# Access Compliance Report

## Public Rights-of-Way

Intersection ID: 30117	Main Street: CLOONEY_LN	Cross Street: DAVIS_FOREST_LN	Location: SE
ADA ID: F01739E745A9	Ramp Type: Perp	Initial Pass/Fail: Fail	Overall Compliance: No
Severity Score: 10			
Codes/Mitigation Info/Possible Solution		Field Measurements/Component Compliance

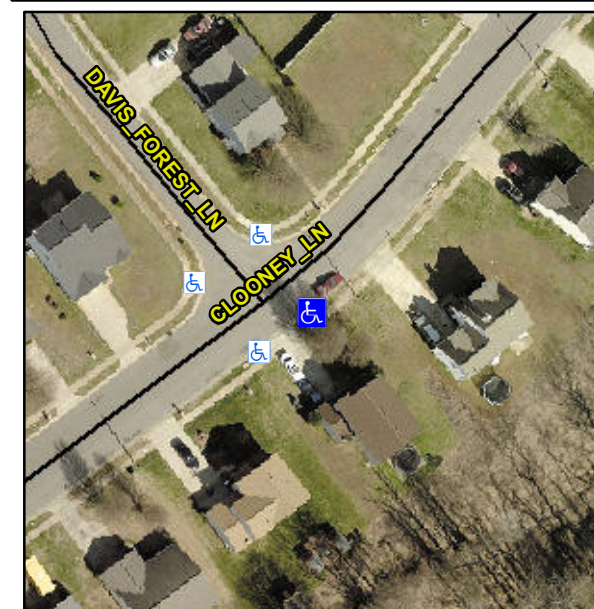
Compliance	Description	Data	Compliance	Description	Data
N/A	Ramp Length (in)	47.5	Yes	Ramp Slope (%)	6.8
No	Ramp Width (in)	42.0	Yes	Ramp XSlope (%)	2.4
N/A	Flare Type LT	N/A	N/A	Flare Type RT	N/A
N/A	Flare Slope LT (%)	N/A	N/A	Flare Slope RT (%)	N/A
N/A	Flare Traversable LT?	N/A	N/A	Flare Traversable RT?	N/A
N/A	Landing Length (in)	N/A	N/A	DWS Provided?	N/A
N/A	Landing Width (in)	N/A	N/A	DWS Contrast?	N/A
N/A	Landing Slope (%)	N/A	N/A	DWS Length (in)	N/A
N/A	Landing X Slope (%)	N/A	N/A	DWS Full Width?	N/A
N/A	Landing Curb? (Y/N)	N/A	N/A	DWS Offset (in)	N/A
N/A	Shared Landing?	N/A			
N/A	Gutter Ponding?	N/A	N/A	Gutter Slope (%)	N/A
N/A	Gutter Lip Ht (in)	N/A	N/A	Gutter X Slope (%)	N/A
N/A	Painted X Walk1?	No	N/A	Painted X Walk2?	N/A
	X Walk 1 Direction	To NW		X Walk 2 Direction	N/A
N/A	X Walk 1 Width (in)	N/A	N/A	X Walk 2 Width (in)	N/A
	X Walk 1 Slope (%)	0.2		X Walk 2 Slope (%)	N/A
	X Walk 1 X Slope (%)	4.6		X Walk 2 X Slope (%)	N/A

**Remove & Replace Entire Ramp.**

**R304.5.1**
